Application No.: 10/640,349

Docket No.: JCLA11051

REMARKS

FIG. 1 (PRIOR ART)

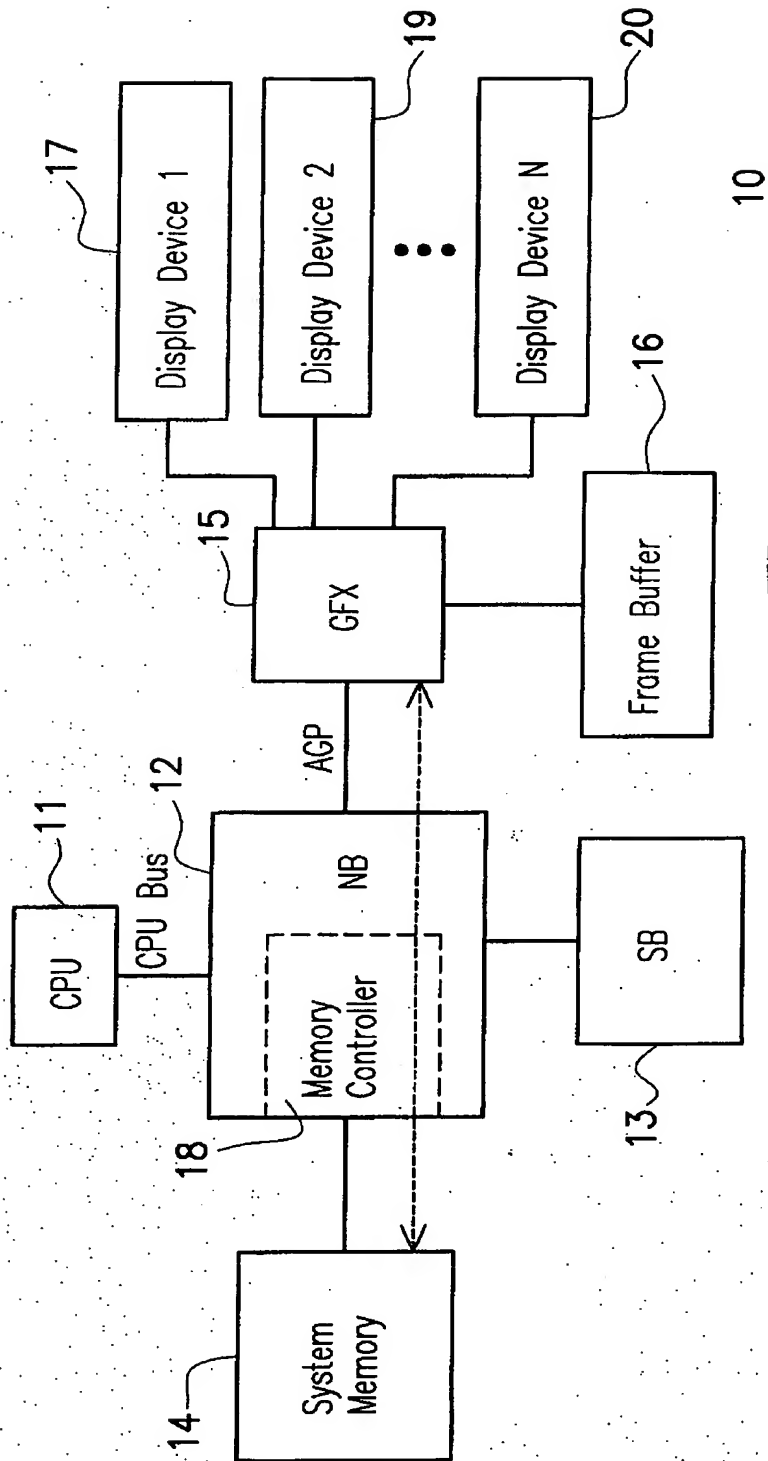
Please amend the drawings by replacing the original filed drawing sheets with the attached clear version of corrected drawing sheets, in which "prior art" marks are appropriately marked in FIGS. 1- 4, as they should be.

The drawings of FIGS. 1-4 are amended and submitted hereby in a clear version.
